CITY OF ALBUQUERQUE

RE: Tierra Serena (Glendesto) Subdivision
Revised Grading Plan Stamp Date: 8/9/18
Drainage Supplement Stamp Date: none
Hydrology File: B18D020

GLENDESTO SUBDIVISION
GRADING & DRAINAGE PLAN

| CITY OF ALBUQUERQUE PUBLIC WORKS DEPARTMENT | |
|--|------------------------|
| TITLE: GLENDESTO SUBDIVISION SAN PEDRO & GLENDALE AVENUE N.E. UTILITY PLAN AND PROFILE | |

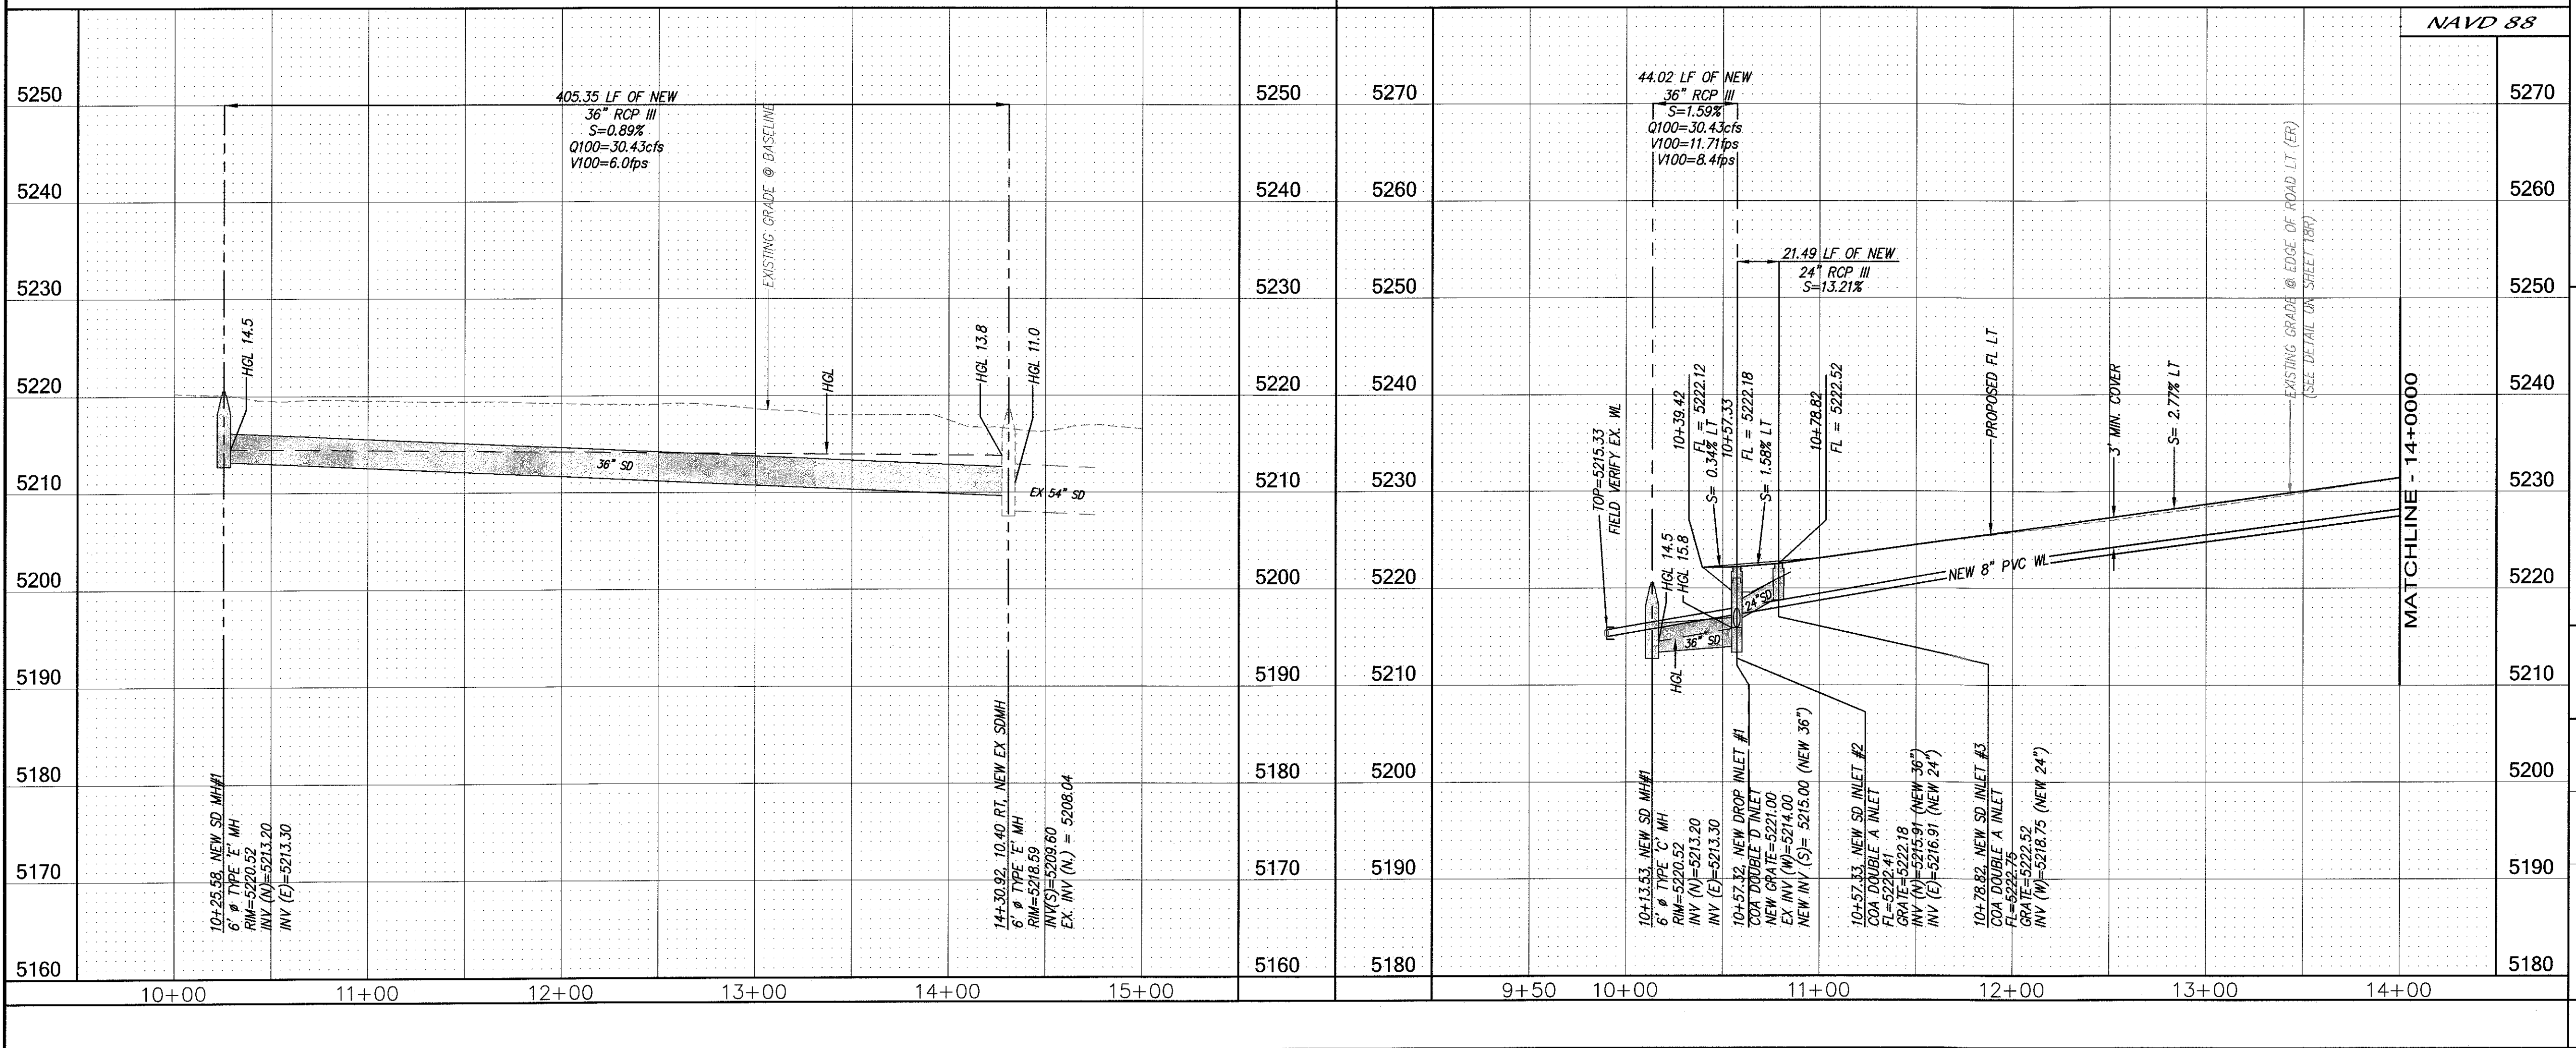
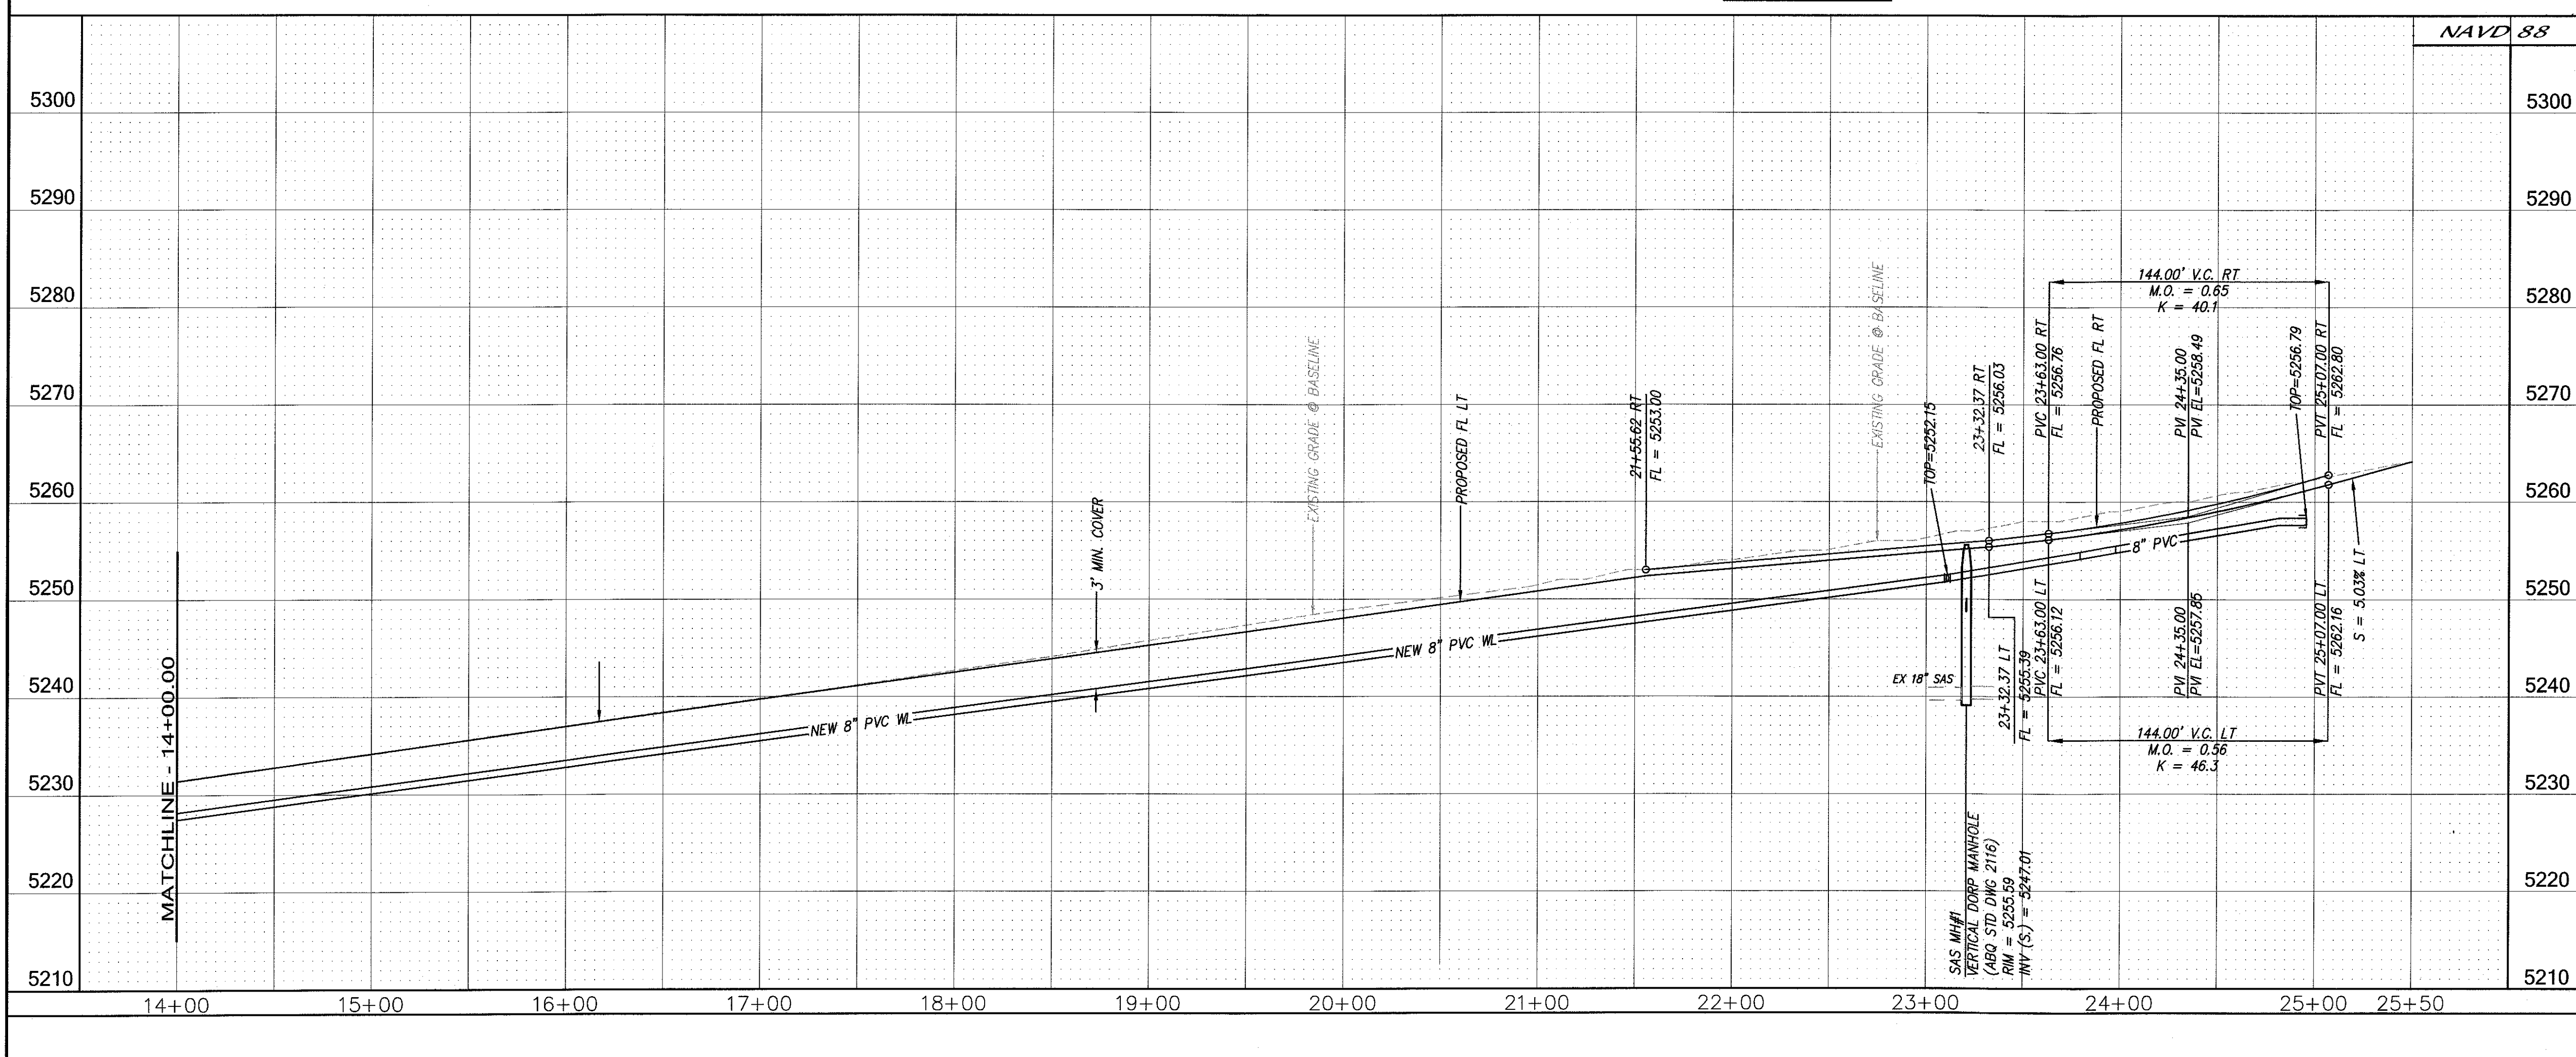
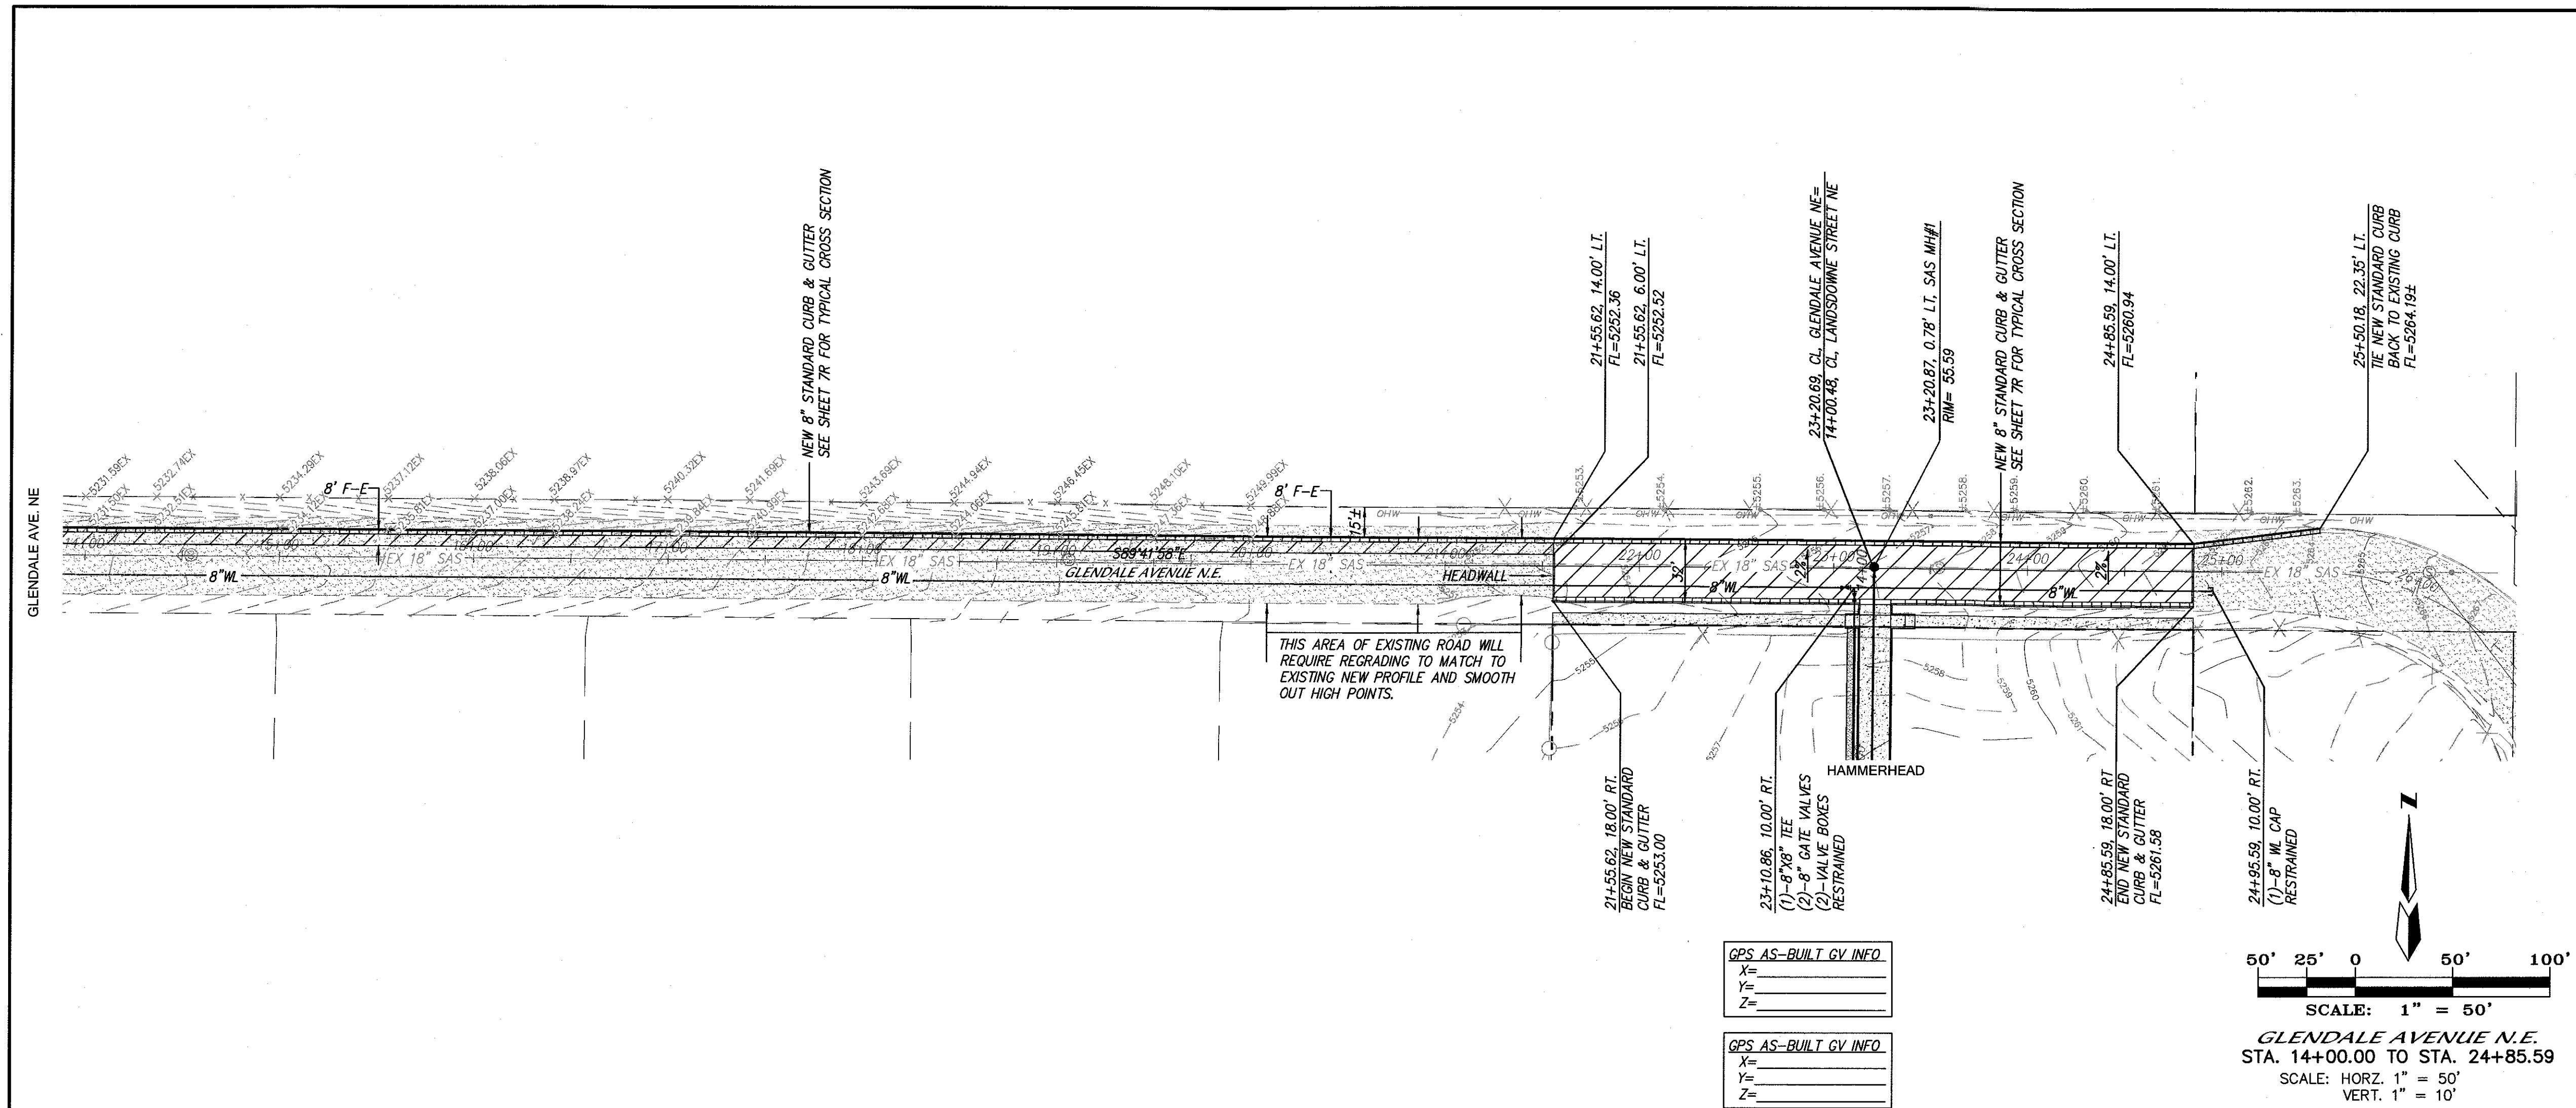
1. 100% interception of the 100-yr flow is required. No bypass will be allowed.
2. Provide HGL calculations and stormdrain profile for the revised stormdrain down the manhole at San Pedro/Glendale.
3. Provide street capacity calculations for the 10-yr storm. Demonstrate that it is contained on the asphalt section.
4. Date the drainage report supplement.
